**STANDARD CONDITION C14: TRANSMISSION LICENCE, LICENSEE'S GRID CODE**

**Decision and direction in relation to consultations H/04, "Grid Code Changes to Incorporate New Generation Technologies and DC Inter-connectors (Generic Provisions)" and SA/2004, "Consultation on Technical Requirements for Windfarms"**

### **Grid Code Modifications H/04 & SA/2004**

### **Grid Code Modifications H/04 & SA/2004**

Figure 3

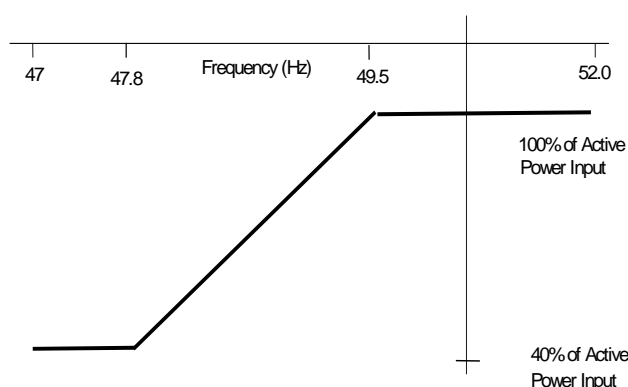
### SC2 - Power Frequency Characteristic for DC Converters

CC.6.3.3 (d) *A **DC Converter Station** must be capable of maintaining its **Active Power** input (i.e. when operating in a mode analogous to **Demand**) from the **GB Transmission System** (or **User System** in the case of an **Embedded DC Converter Station**) at a level not greater than the figure determined by the linear relationship shown in Figure 3 for **System Frequency** changes within the range 49.5 to 47 Hz, such that if the **System Frequency** drops to 47.8 Hz the **Active Power** input decreases by more than 60%.*

SKM raised an issue with respect to the DC Interconnector proposals. NGC considered SKM's comments and was supportive of a modification to the H/04 drafting. This was addressed in the Supplementary Changes document (SC2). Two respondents supported the SKM modification and there were no objections.

**Figure CC.A.4.1 (a)**

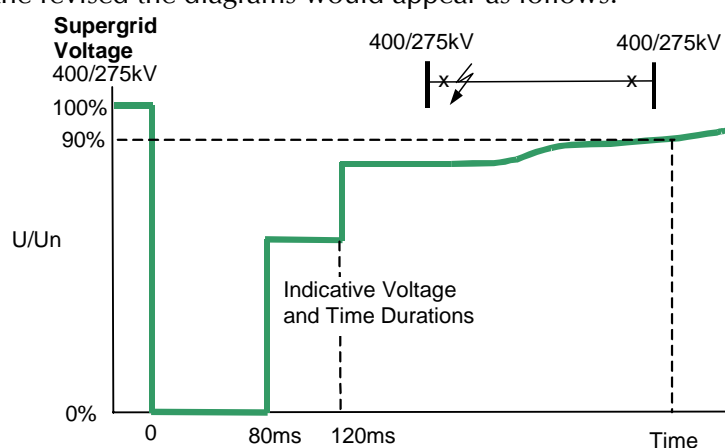
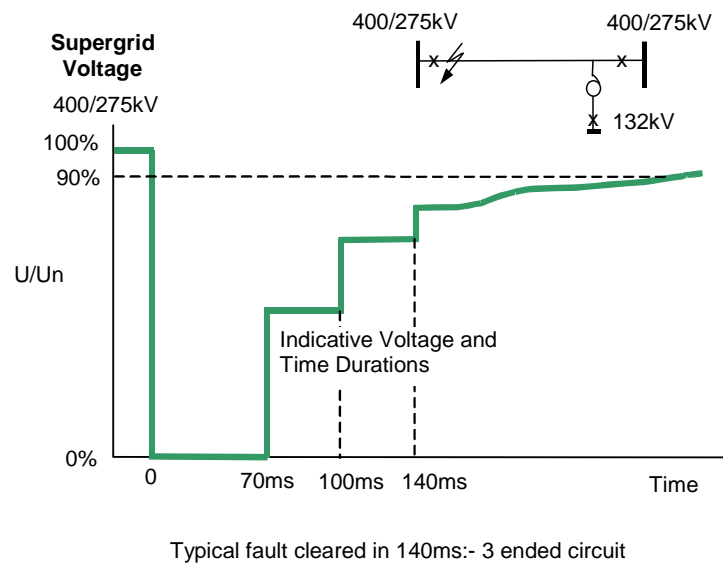
SKM proposed that the illustrative figures in CC.A.4.2 be revised by removal of vertical arrows and addition of 400/275kV to the labels on the vertical axes. National Grid agrees and the revised the diagrams would appear as follows.

### POWER PARK MODULE PERFORMANCE CHART AT THE CONNECTION POINT OR USER'S SYSTEM ENTRY POINT

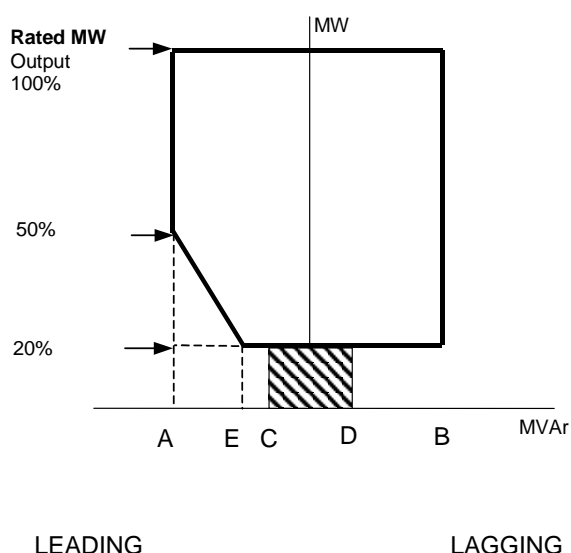
**AC1** – makes a modification to CC.6.3.2 in respect of the leading capability of a Power Park Module at low power outputs. This modification is required to avoid unnecessary costs where a reduced leading capability is acceptable.

*Point A is equivalent (in MVar) to: 0.95 leading **Power Factor** at **Rated MW** output*

Figure 5

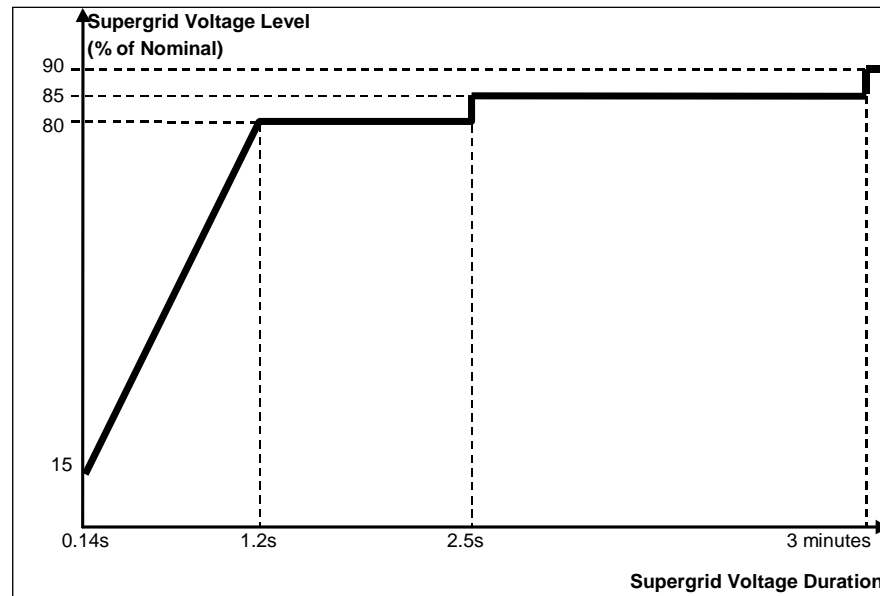
There is some interaction in the above change proposals particularly in CC.6.3.15(b)(ii). For clarity the complete paragraph CC.6.3.15 is reproduced below:

- (i) remain transiently stable and connected to the **System** without tripping of any **Generating Unit or Power Park Module** and / or any **Power Park Unit**, for balanced **Supergrid Voltage** dips and associated durations anywhere on or above the heavy black line shown in Figure 5. Appendix

**AC5** – clarifies the meaning of "constituent element" in CC.6.3.15(b). This modification is required to clearly define the requirements to maintain active power output from generation during and after faults and voltage dips without applying to auxiliary systems that do not impact active power output.
